KETCHUM FIRE STATION DESIGN REVIEW
STAFF REPORT
KETCHUM PLANNING AND ZONING COMMISSION
REGULAR MEETING OF FEBRUARY 10, 2020

PROJECT: Ketchum Fire Station

FILE NUMBER: P20-013

APPLICATION: Design Review

A2.02

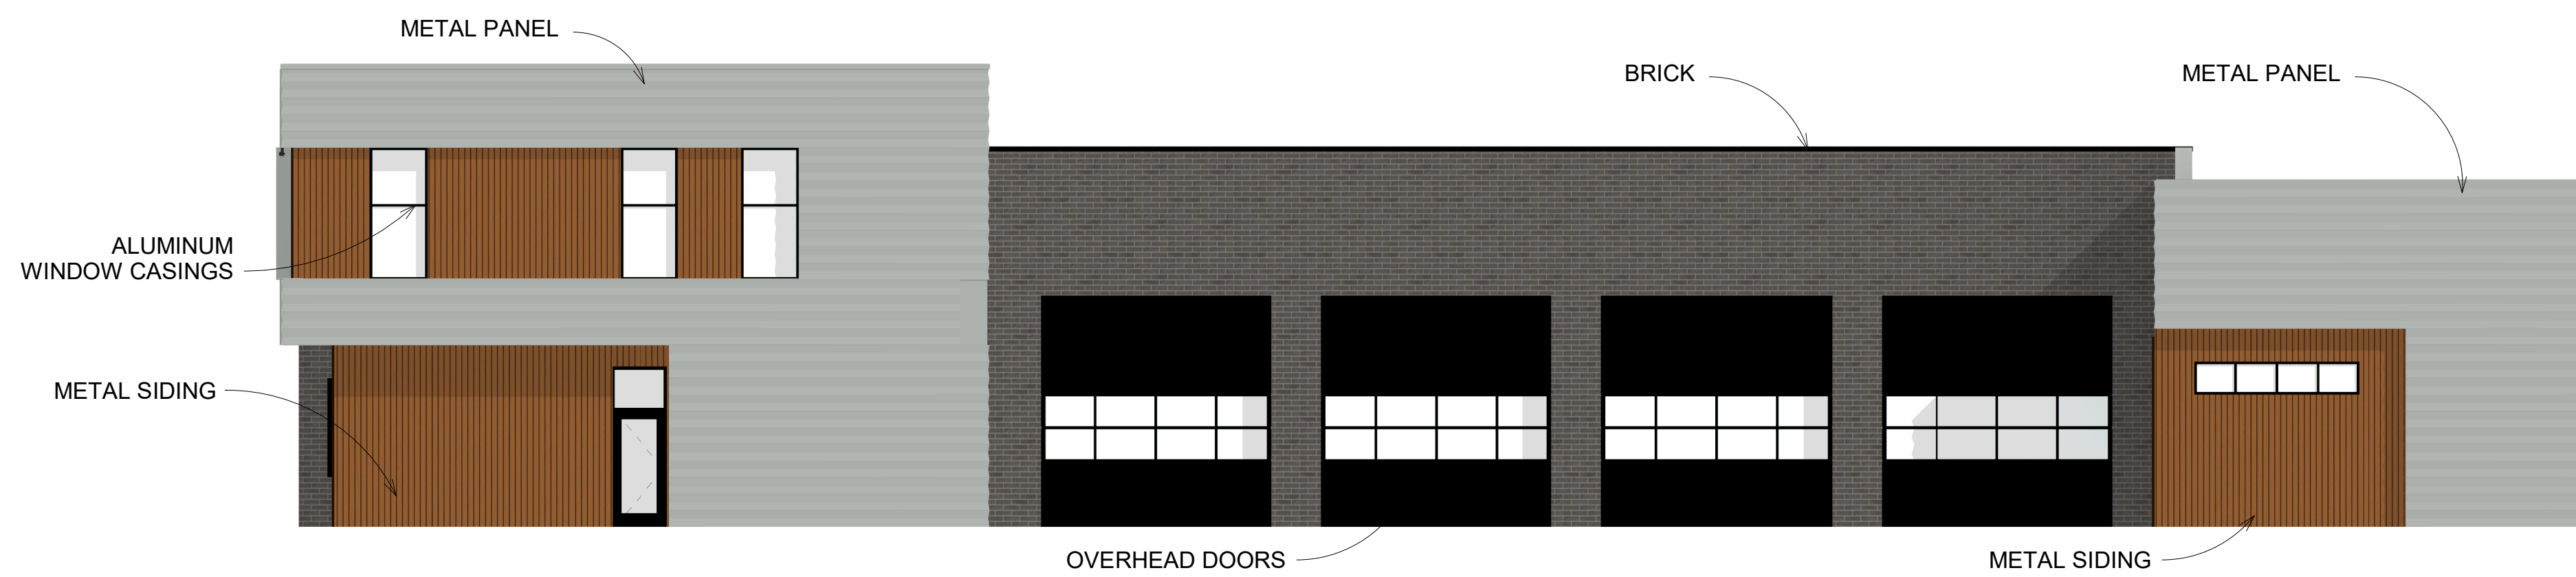
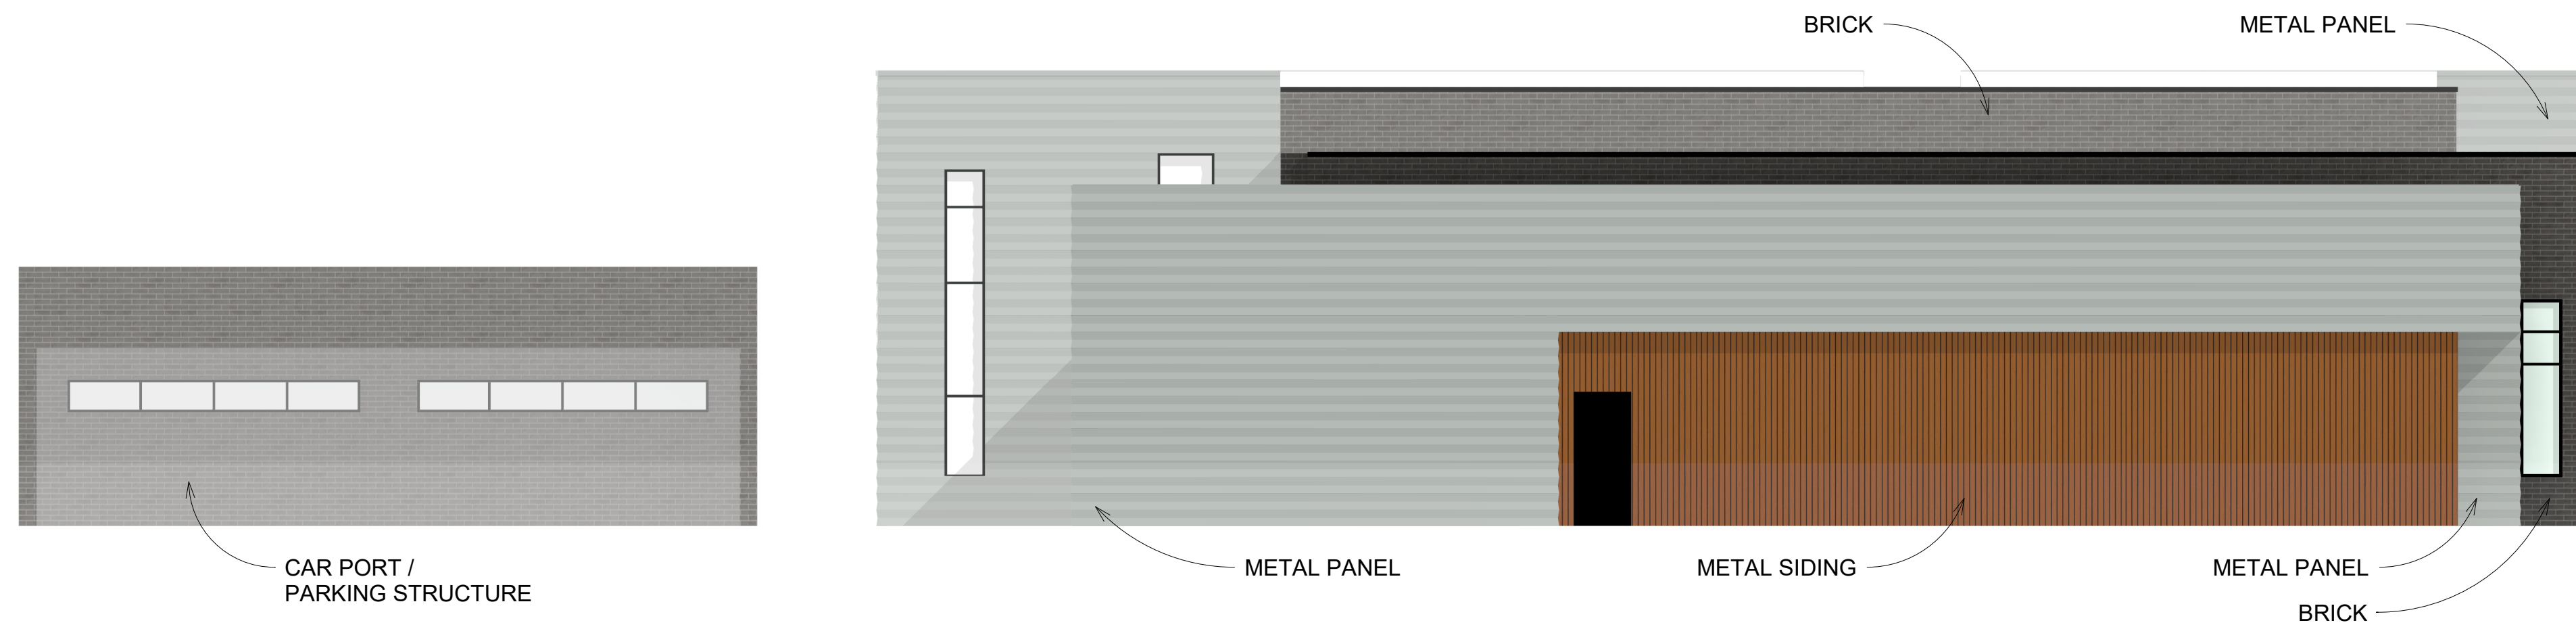
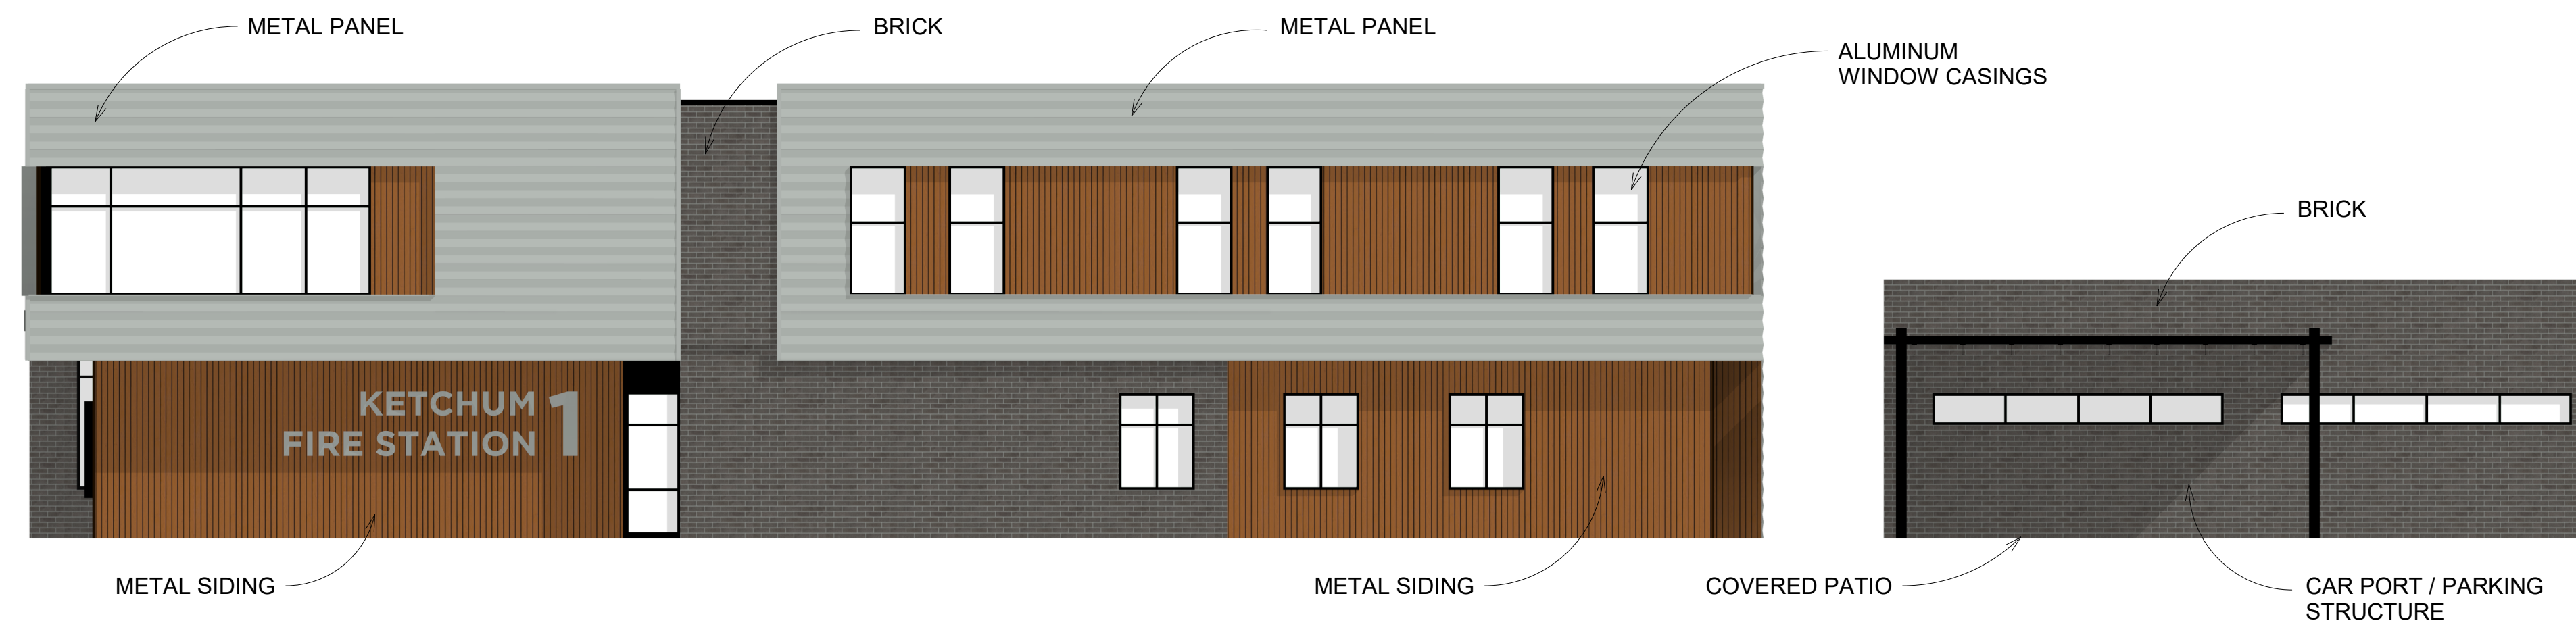
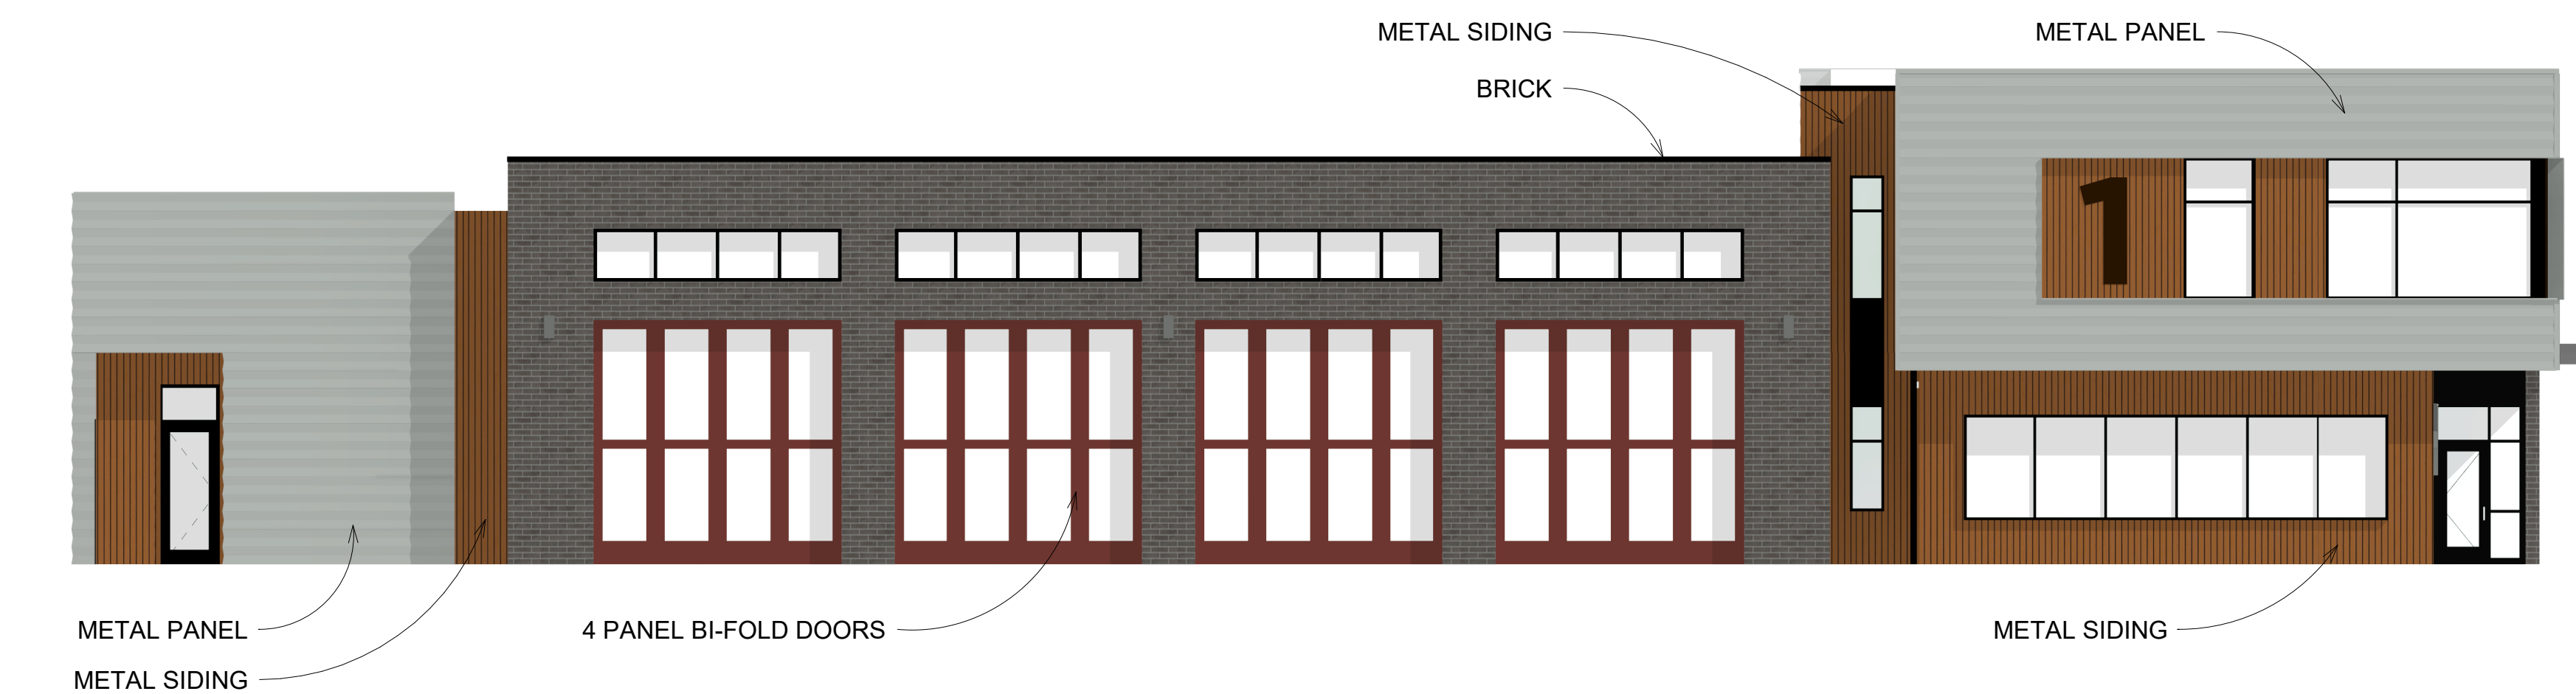
<i>Staff Comments</i>	<i>The exterior elevations (Sheet A3.00) show the proposed materials, colors, and signage. The façade design alternates gray horizontal metal panels with brown vertical metal siding. Projecting towards</i>

C4.00

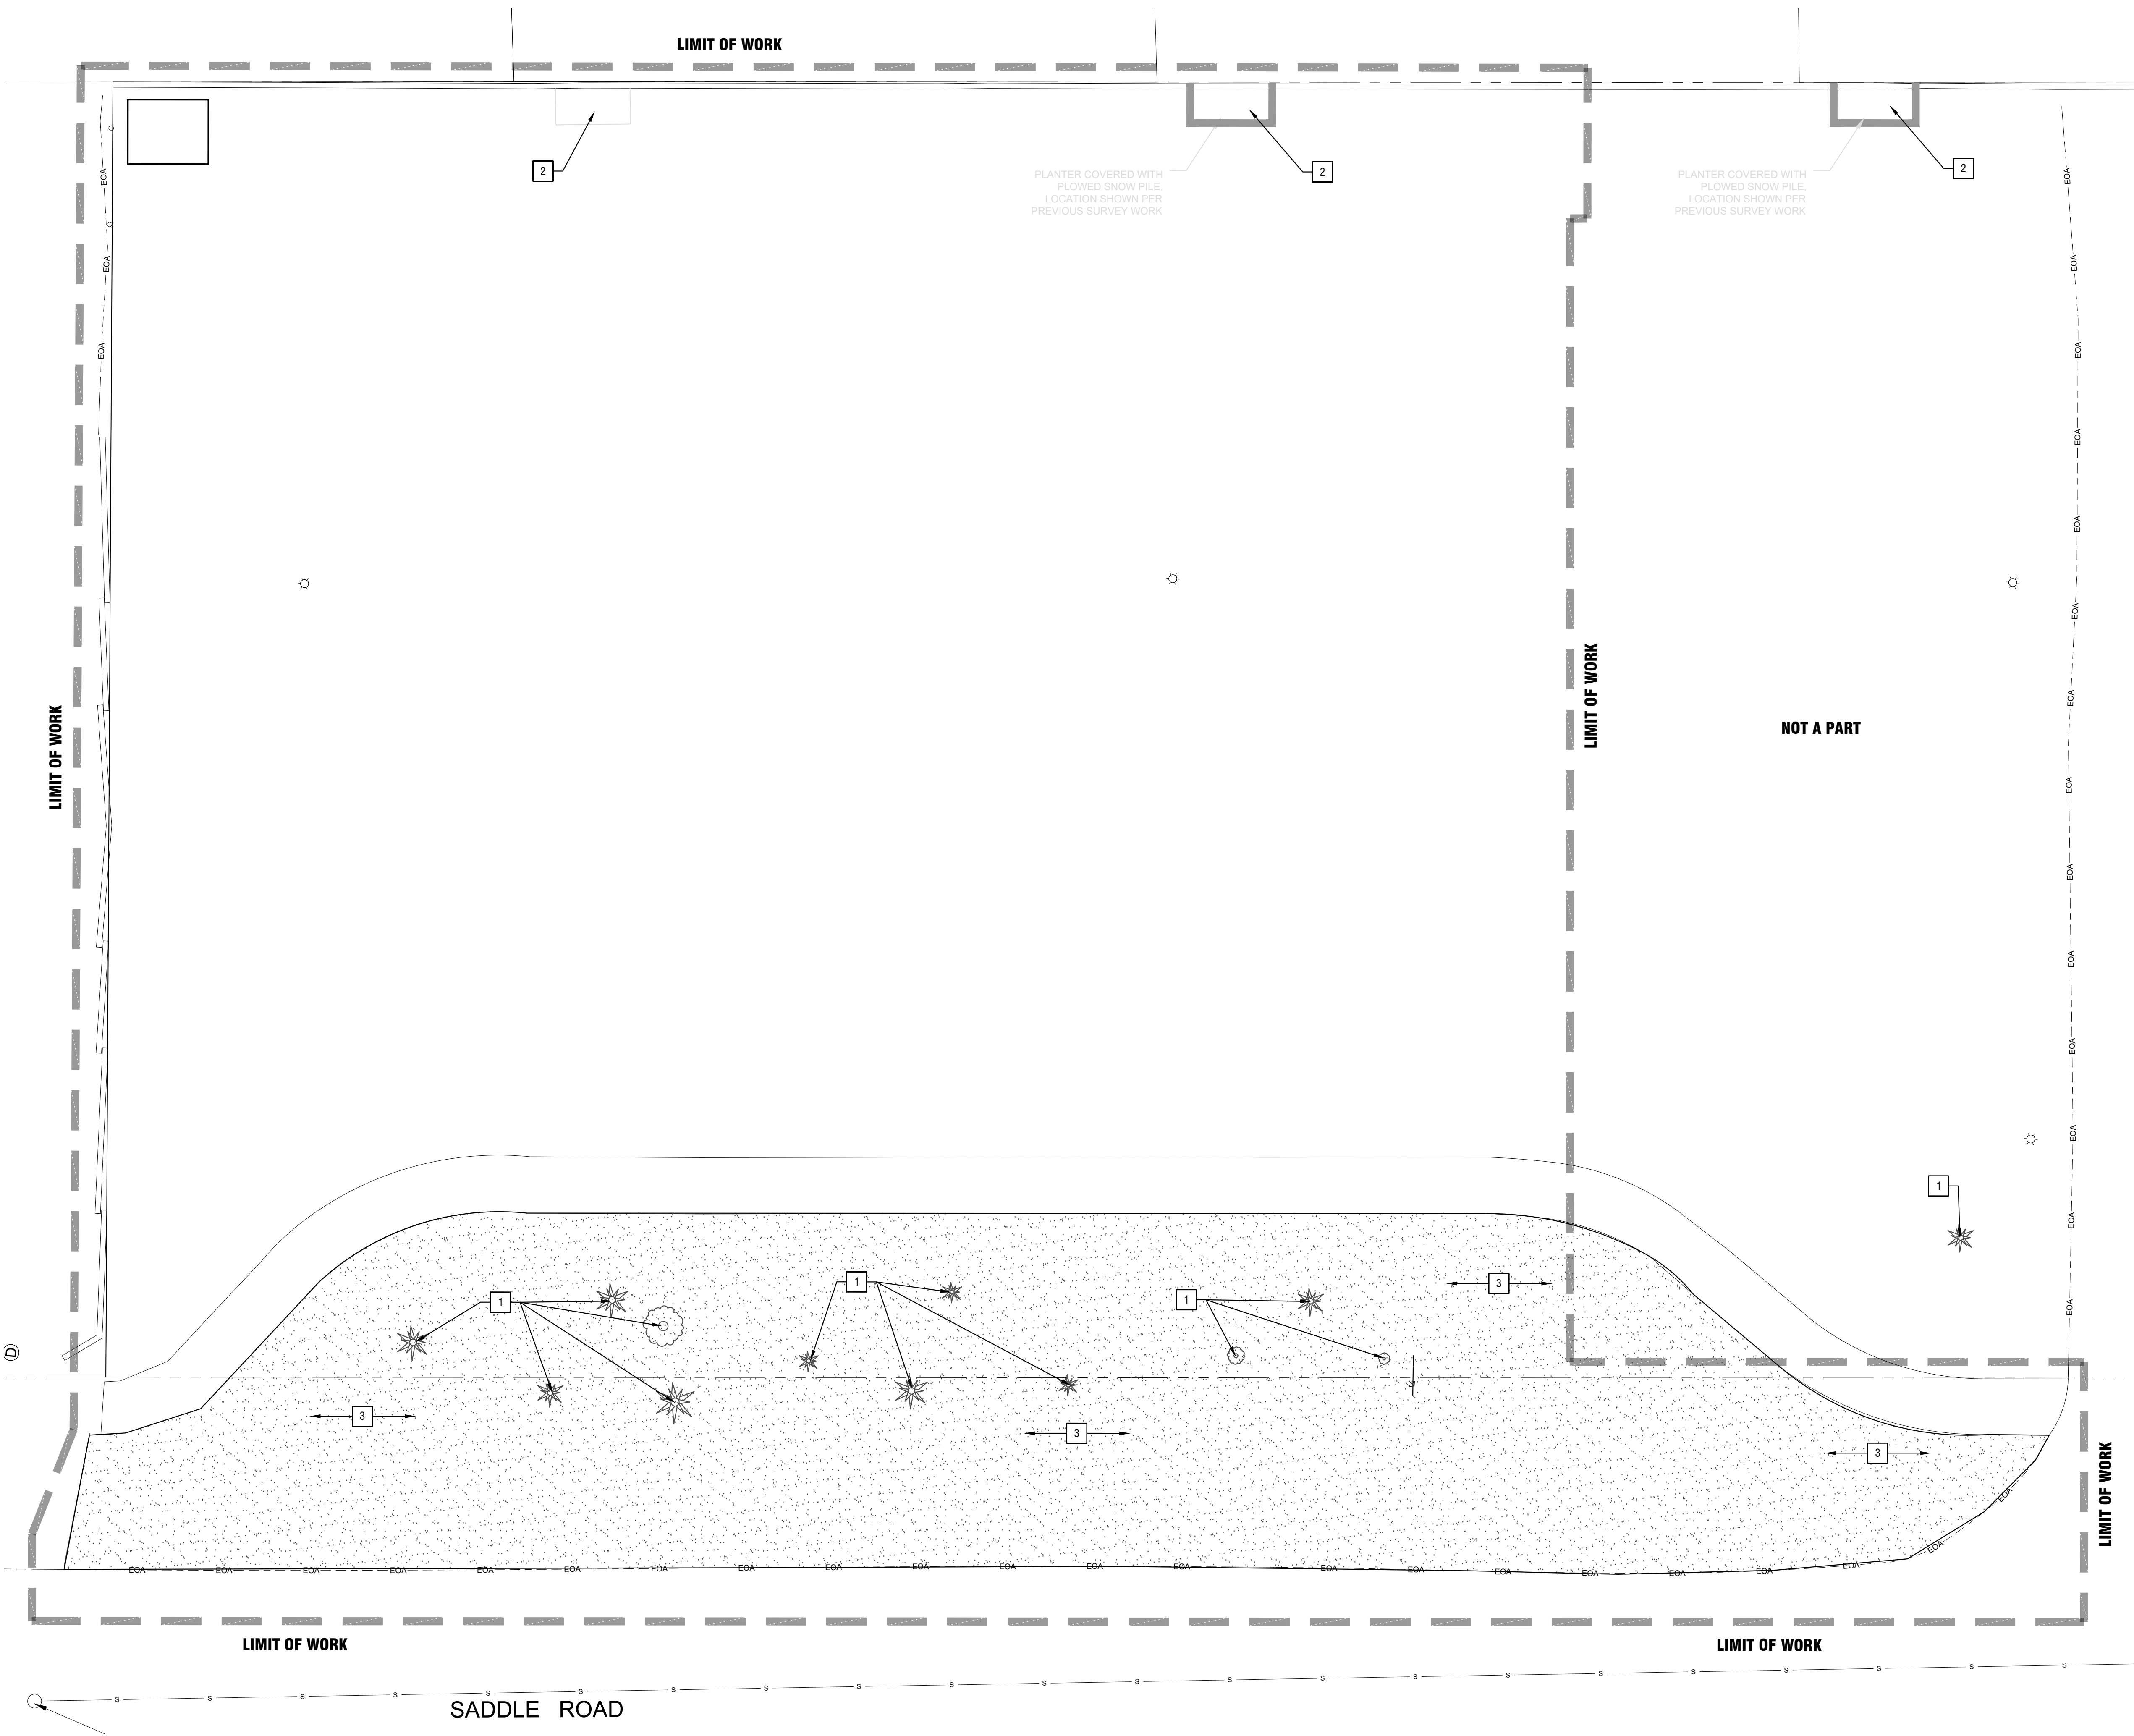
<i>Staff Comments</i>	<i>Sheet C4.00 of the project plans show utility connections and locations. All utilities necessary for the fire station must be improved and installed at the sole expense of the applicant. Prior to issuance of a Building Permit, the applicant must secure a will-serve letter from Idaho Power. Final plans will be reviewed and approved by the Utilities Department prior to issuance of a Building Permit for the project. See Table 2 for review comments and conditions from the Utilities Department.</i>
<input checked="" type="checkbox"/>	<input type="checkbox"/>	<input type="checkbox"/>	17.96.060.D2 Utilities	Utilities shall be located underground and utility, power, and communication lines within the development site shall be concealed from public view.
			<i>Staff Comments</i>	<i>All utilities within the development site shall be underground and concealed from public view. See above analysis for Ketchum Municipal Code §17.96.060D1. The generator located at the northeast corner of the project site must be fully screened from public view.</i>
